2023 SMP Package III (Hermine Blvd, Bartmer Ave)
Solicitation No. CO-00574
Job No. 21-5056 (Water) & 21-5554 (Sewer)

ADDENDUM 1
September 14, 2022

5710 W. HAUSMAN RD., SUITE 115 SAN ANTONIO, TEXAS 78249 FIRM NO. F-15085 210.860.9224		
	2023 SMP PACKAGE III (HERMINE BLVD, BARTMER AVE) BARTMER AVE. WATER MAIN REPLACEMENT BEGIN PROJECT TO STA 17+00		
DWG: CV	SUBMITTAL	SAWS PROJECT NO. 21-5056	SHEET NO. W-9

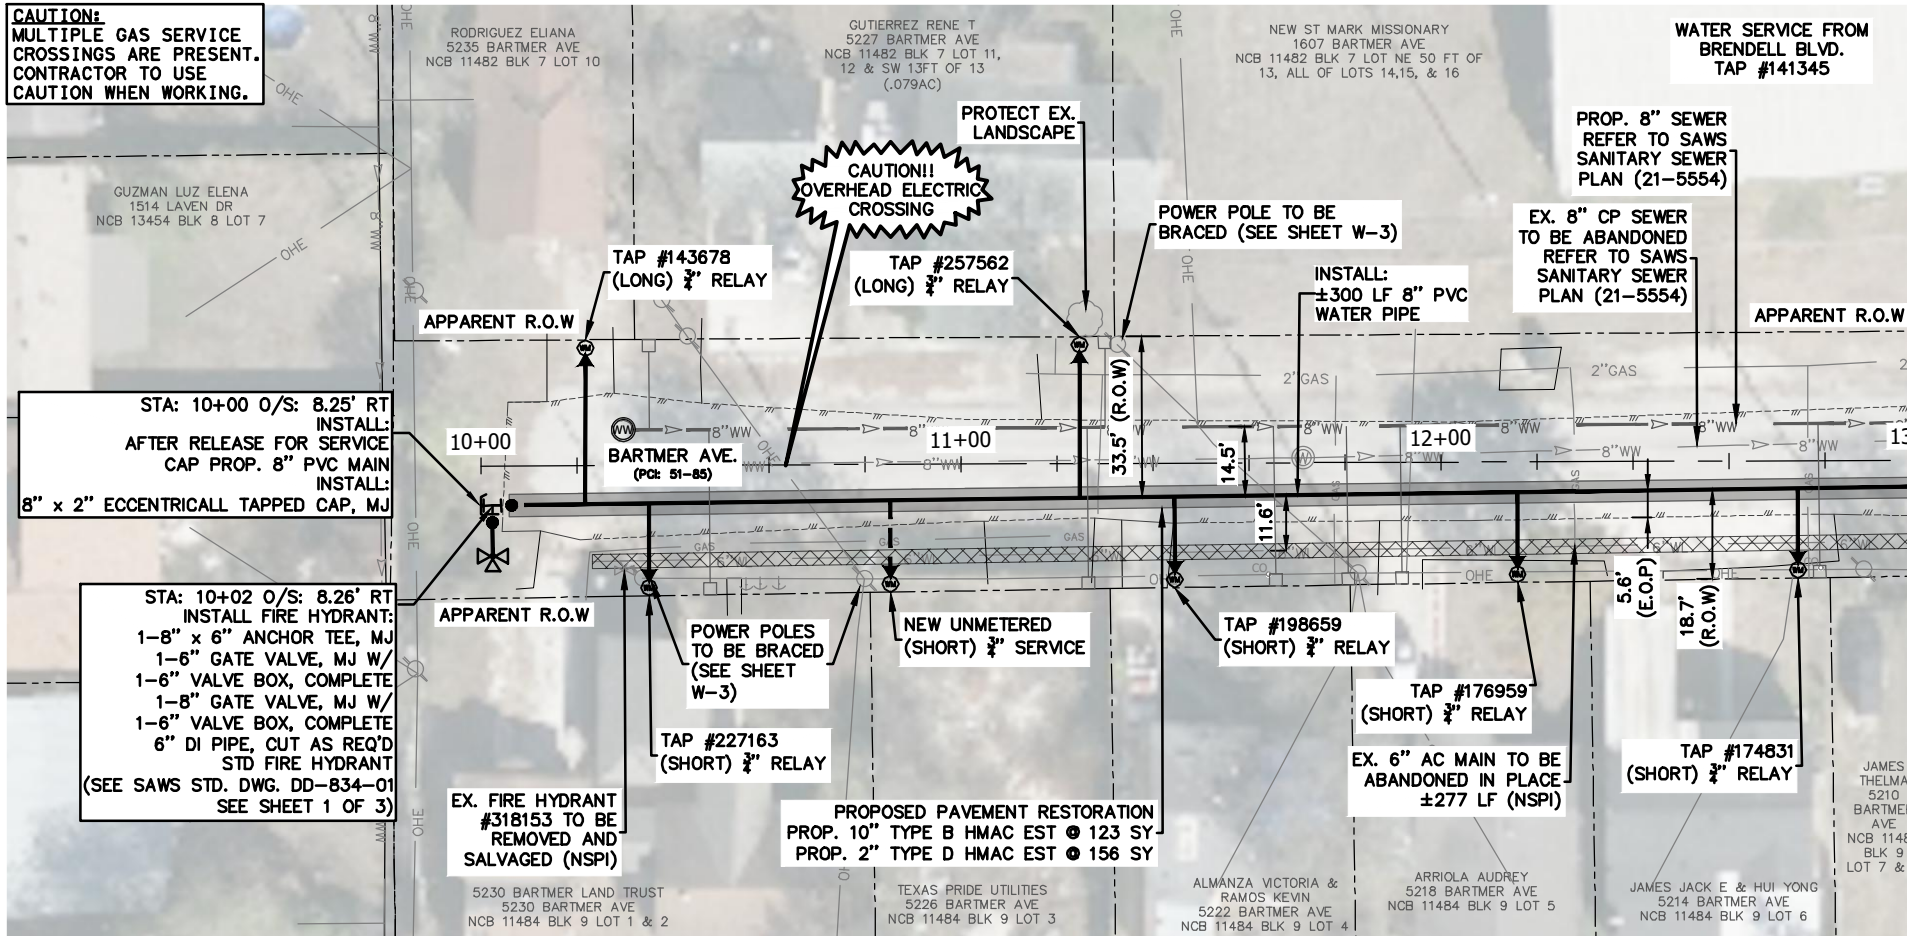
1. **The construction duration has been increased from 365 calendar days to 395 calendar days to account for additional material delays.**
2. **Sheet W-9 Bartmer Ave. Water Main Replacement Begin Project To Sta 17+00 – Note 8 "CONTRACTOR TO FULLY RESTRAINED ALL PIPE" has been replaced with "SEE SHEET W-23 FOR RESTRAINED LENGTH TABLE".**

- SEE SHEET W-23 FOR RESTRAINED LENGTH TABLE. REFER TO SAWS SPECIFICATION 839 REGARDING RESTRAINED LENGTH.
 - SAWS SHALL MACHINE CHLORINATE NEW WATER MAINS UNLESS OTHERWISE NOTED ON PLANS.

DWG: CV	SUBMITTAL	SAWS PROJECT NO. 21-5056	SHEET NO. W-10
CHK DWG: AYR	100% SUBMITTAL

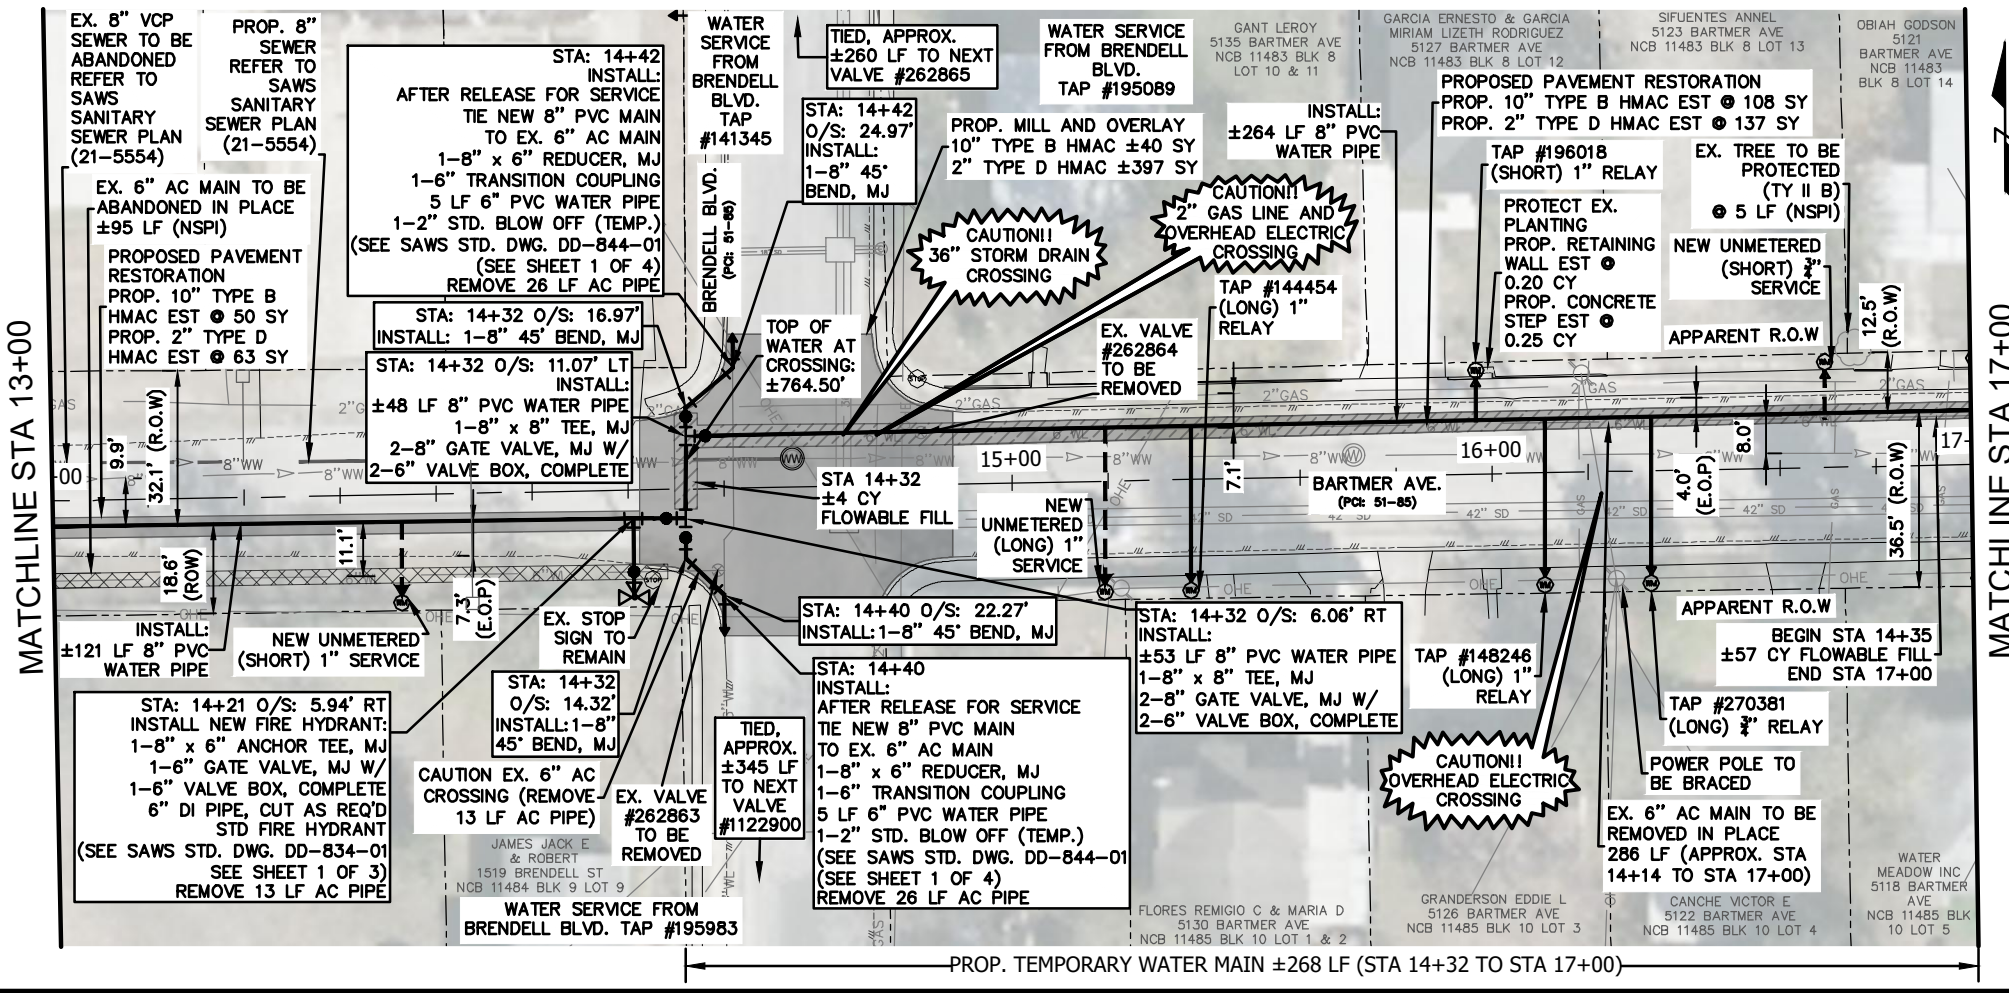
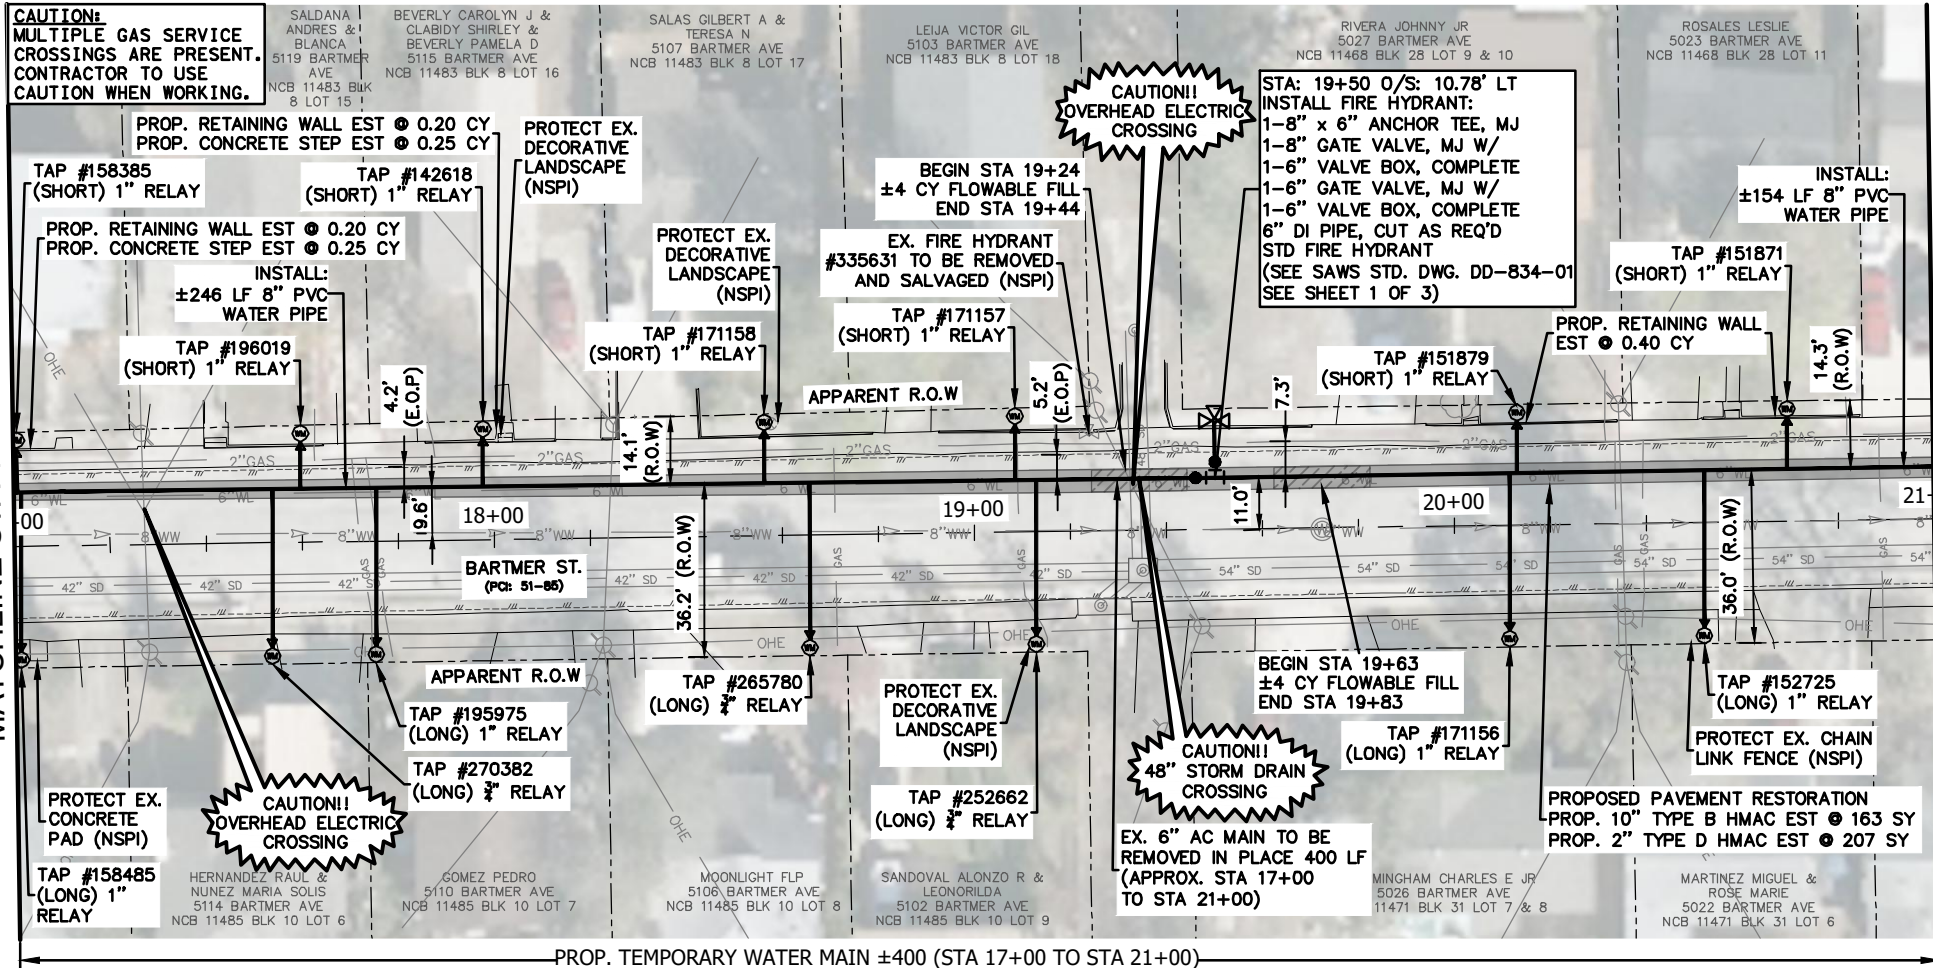
3. **Sheet W-10 Bartmer Ave. Water Main Replacement Sta 17+00 To Sta 25+00 – Note 8 "CONTRACTOR TO FULLY RESTRAINED ALL PIPE" has been replaced with "SEE SHEET W-23 FOR RESTRAINED LENGTH TABLE".**

4. **Sheet W-10 Bartmer Ave. Water Main Replacement Sta 17+00 To Sta 25+00 – tie-in callouts at Benrus Blvd. to include the following “CONTRACTOR TO PROVIDE THRUST BLOCKING AT TIE-IN TO EXIST MAIN”**

- SEE SHEET W-23 FOR RESTRAINED LENGTH TABLE. REFER TO SAWS SPECIFICATION 839 REGARDING RESTRAINED LENGTH.
 - SAWS SHALL MACHINE CHLORINATE NEW WATER MAINS UNLESS OTHERWISE NOTED ON PLANS.

DWG: CV	SUBMITTAL	SAWS PROJECT NO. 21-5056	SHEET NO. W-11
CHK DWG: AYR	100% SUBMITTAL

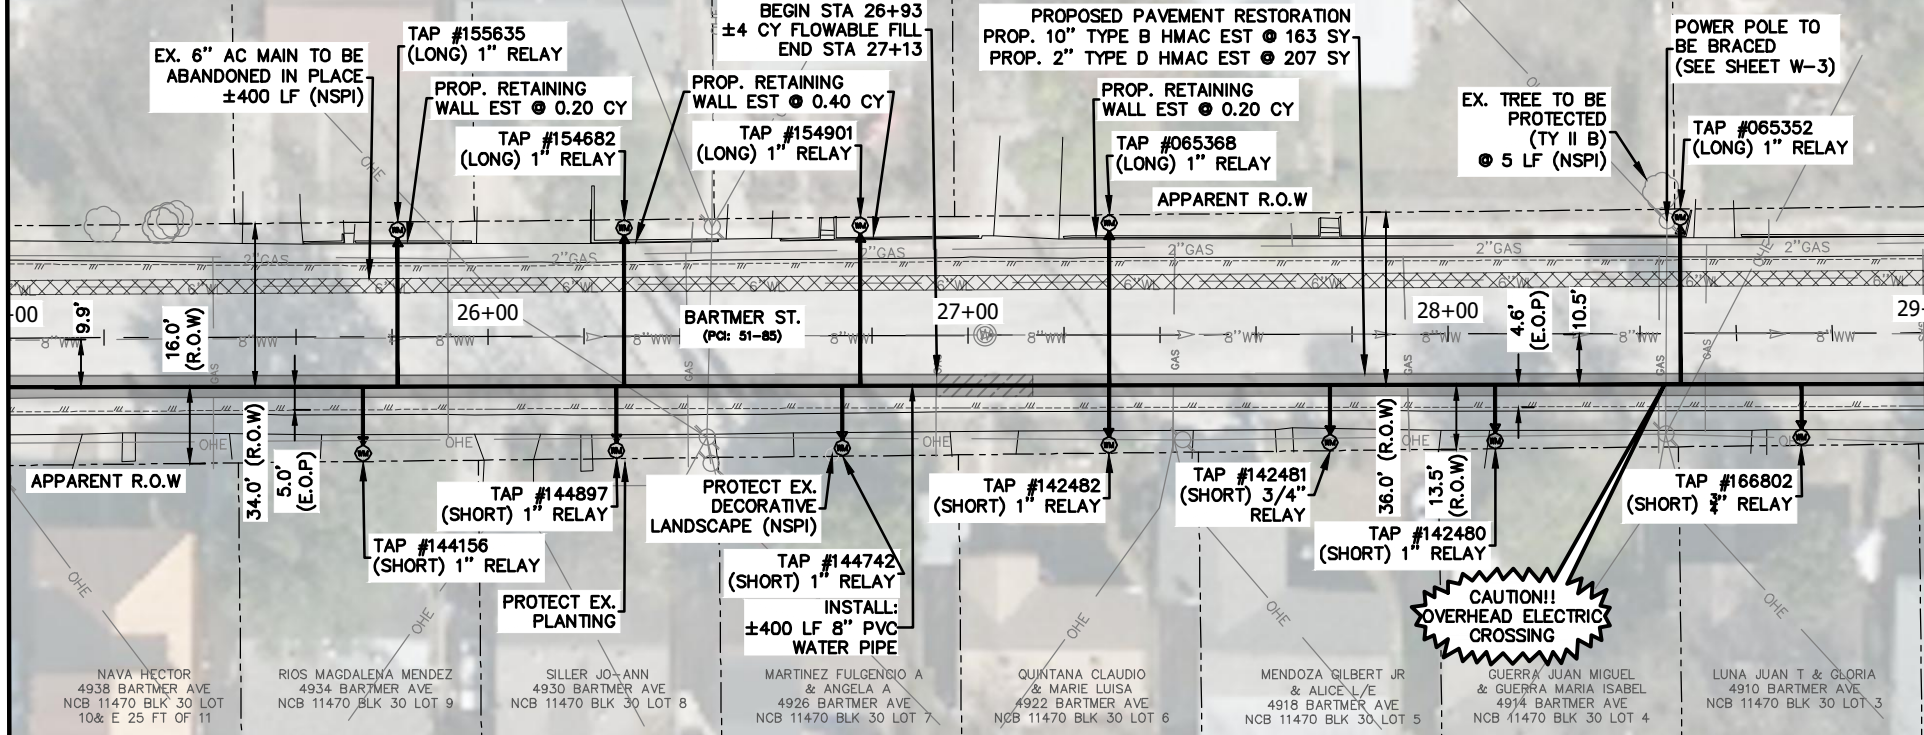
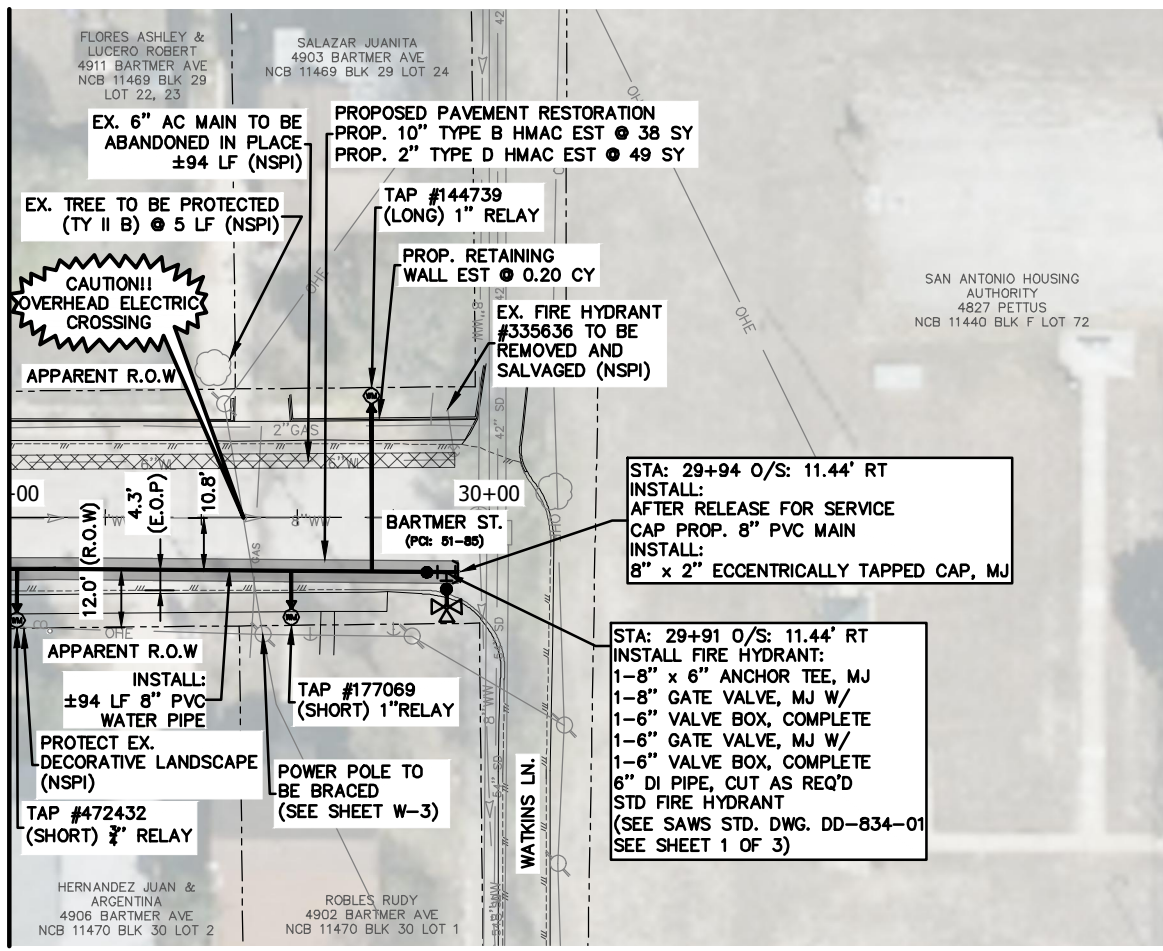
5. **Sheet W-11 Bartmer Ave. Water Main Replacement Sta 25+00 To End Project – Note 8 "CONTRACTOR TO FULLY RESTRAINED ALL PIPE" has been replaced with "SEE SHEET W-23 FOR RESTRAINED LENGTH TABLE".**

- SEE SHEET W-23 FOR RESTRAINED LENGTH TABLE. REFER TO SAWS SPECIFICATION 839 REGARDING RESTRAINED LENGTH.
 - SAWS SHALL MACHINE CHLORINATE NEW WATER MAINS UNLESS OTHERWISE NOTED ON PLANS.
